Technical Service BULLETIN

January 10, 2005

MULTI-DISPLAY FUNCTIONS ARE INOPERATIVE

'04 Highlander, Land Cruiser & Prius

Highlander Multi-Display Connectors:

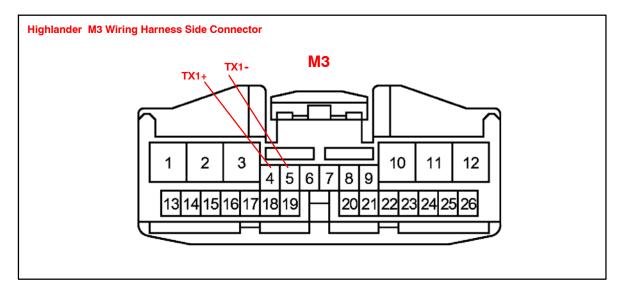
- Check all the TX terminals on the multi-display connectors (please see connector diagrams) and confirm the terminals are fully seated. Replace any damaged terminals or connectors.
- 2. Confirm the connectors to the multi-display are fully seated. Replace any damaged connectors.
- 3. If all the TX terminals are tight and the connectors are fully seated, replace the multi-display.
